C0960-006
May 20, 2020

**Re: Site Review Permit & Conditional Use Permit for Parking Applications
Proposed Multi-Family Development, 105 Bartlett Street, Portsmouth, NH**

The enclosed revised plans and supplemental materials have been provided to address comments received from the Technical Advisory Committee (TAC) at their meeting held on May 5, 2020. Also enclosed is a Site Review Comment Response that includes responses to City staff comments.

City of Portsmouth TAC, May 05, 2020:			
	TAC Comment	Applicant Response	Sheet
TAC Comments from 5/4 Correspondence:			
1	Plans list proposed building height 54 story and 50' for buildings B and C, this appears to be a typo as the building is proposed to be 5 stories using the overlay district zoning. Please correct.	The site data table has been revised to a 4 story and 50' for buildings B and C.	C-102
2	A detailed building height plan should be submitted showing the average grade plane and heights along the perimeter of the building.	An average grade plane exhibit has been added to the submission package.	Grade Plane Exhibit
3	An application for a lot line adjustment is also being submitted, please clarify on plan set if the lot dimens

FIRE TRUCK - REAR BUILDING ACCESS

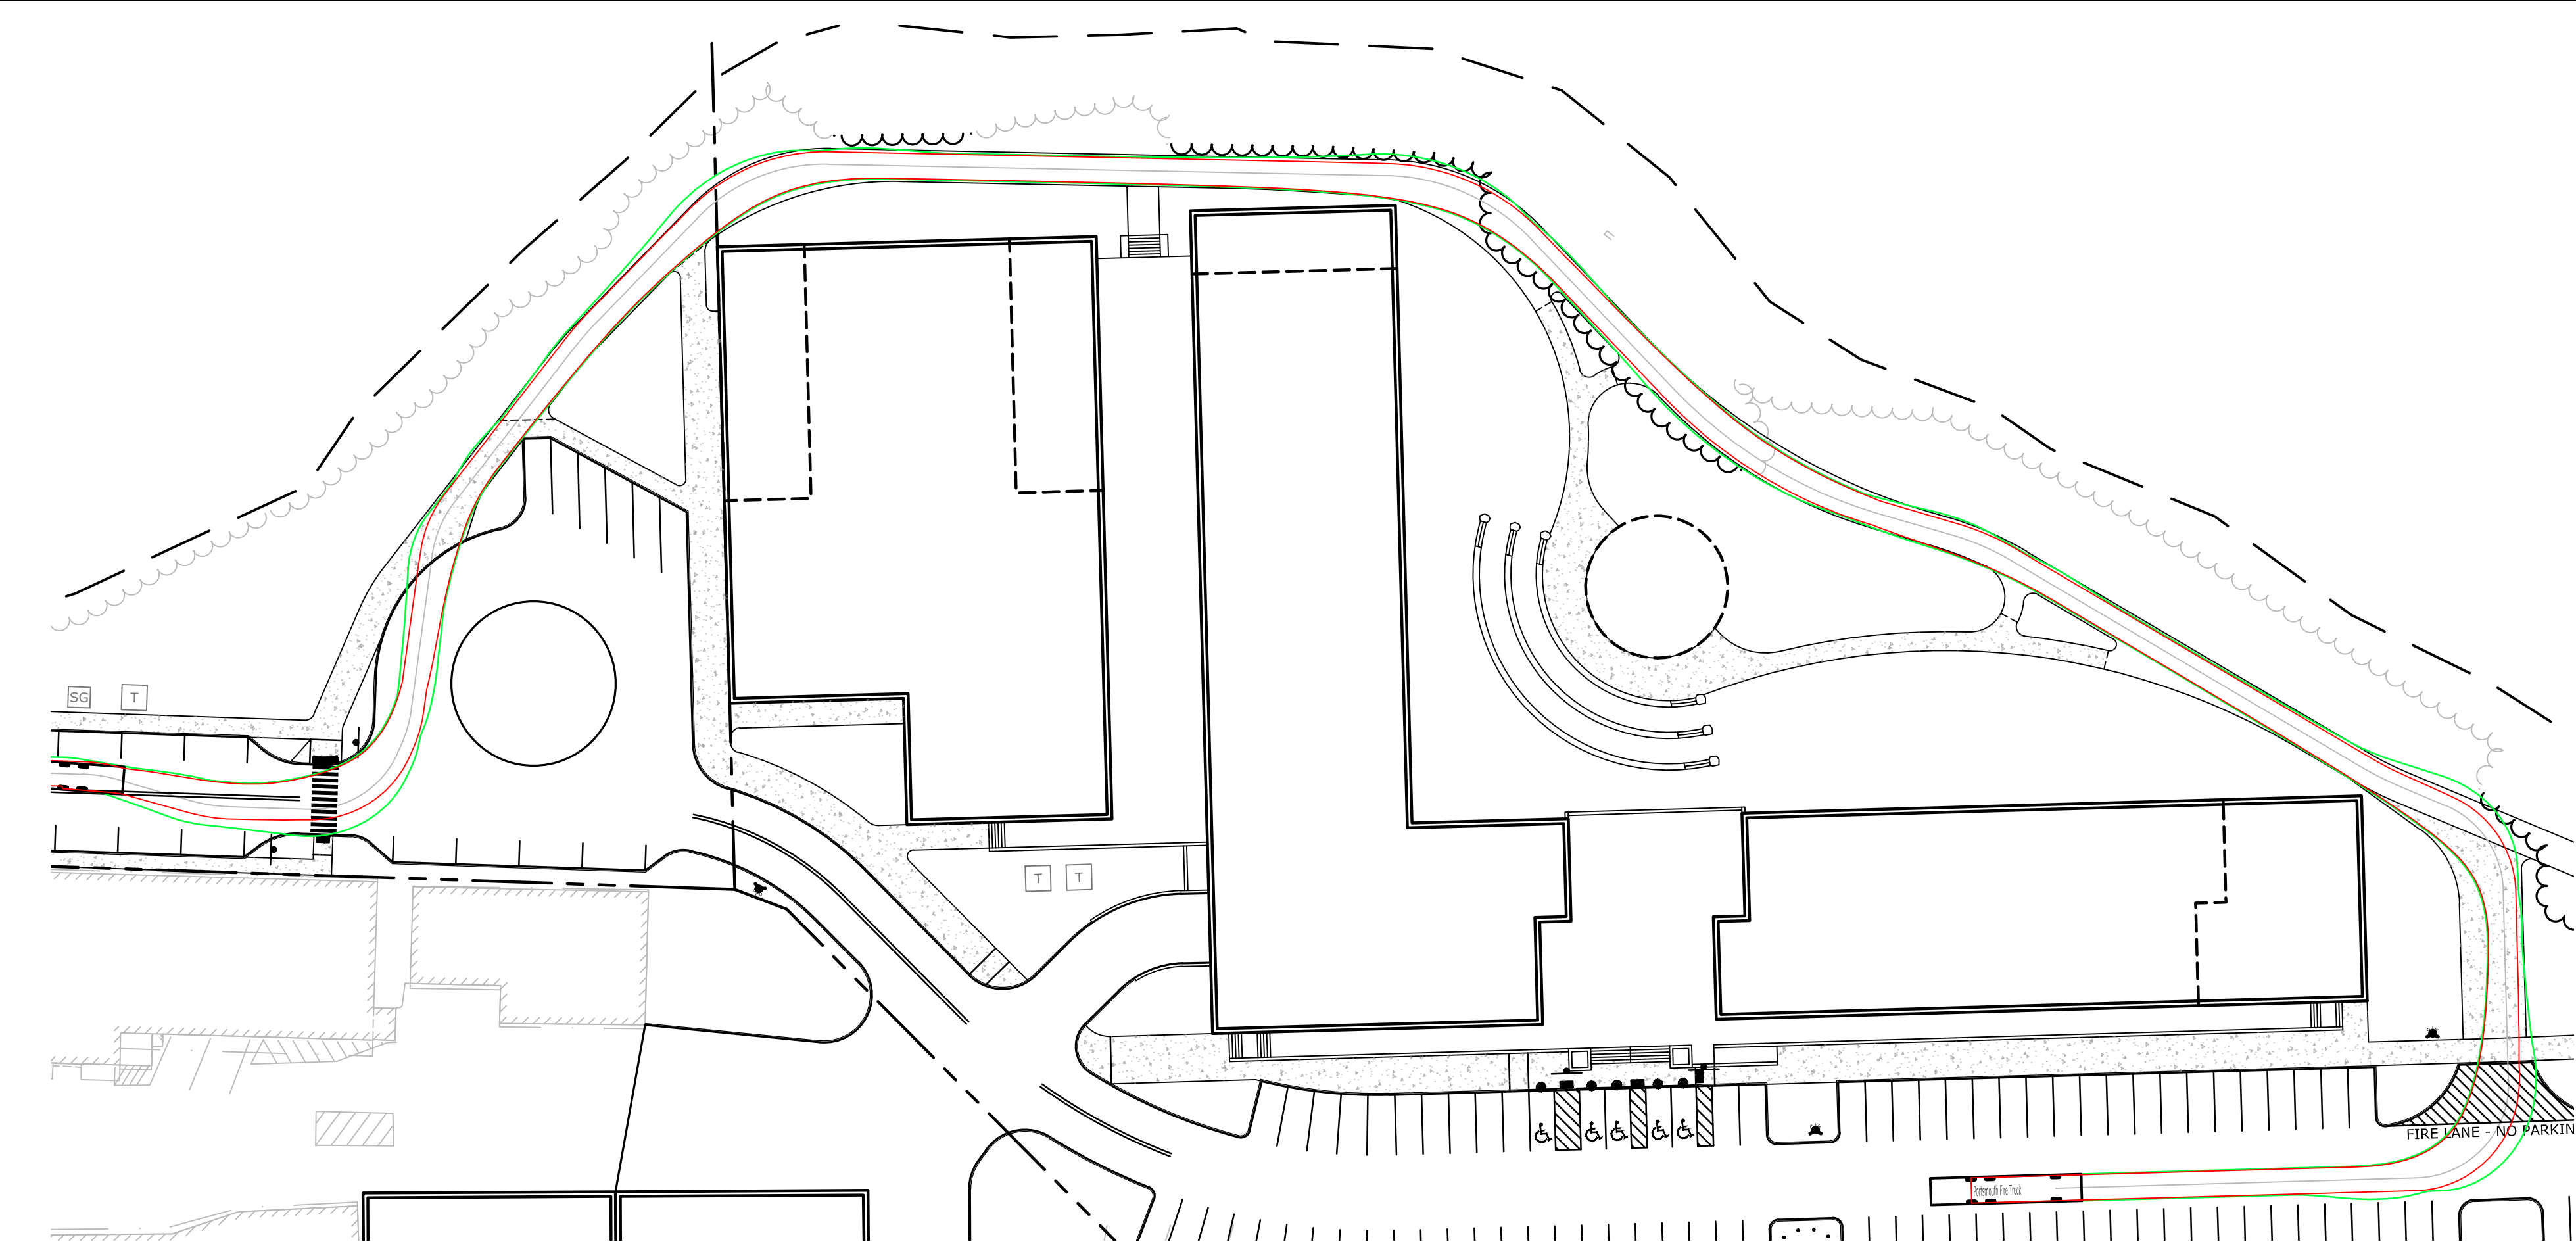
Additional Comments from 5/5 TAC Meeting:			
34	Fire department is concerned with access to Building B.	A fire truck turnaround has been added to the northeast of Building A. The turnaround has been extended to the future multi-use path to allow for emergency vehicle access in the rear of the buildings. As shown on the turning templates, a fire truck has the ability to access rear of Building B if necessary.	C-102 & C-102.2, Truck Turning Exhibit
35	Buildings A & B may be considered as one building for fire code purposes due to the connected basement.	All three (3) buildings will be designed to meet applicable fire codes. Per zoning, Buildings A & B are measured as two (2) building footprints based on the average grade plane elevation shown in the enclosed Grade Plane Exhibit.	Grade Plane Exhibit
36	Applicant shall consider the potential to use the multi use path as fire access in rear of building.	A fire truck turnaround has been added to the northeast of Building A. The turnaround has been extended to the future multi-use path to allow for emergency vehicle access in the rear of the buildings. As shown on the turning templates, a fire truck has the ability to access rear of Building B if necessary.	C-102 & C-102.2, Truck Turning Exhibit

43	Show fire truck template through the site, overhang hits cars at cul-de-sac exit.	Fire truck turning template has been updated showing movement through the site.	Truck Turning Exhibit
44	Check previously approved road in to see if variances were required for parking in front of the Ricci design center.	A proposed easement is shown for the parking that extends into the proposed road lot.	C-301.1
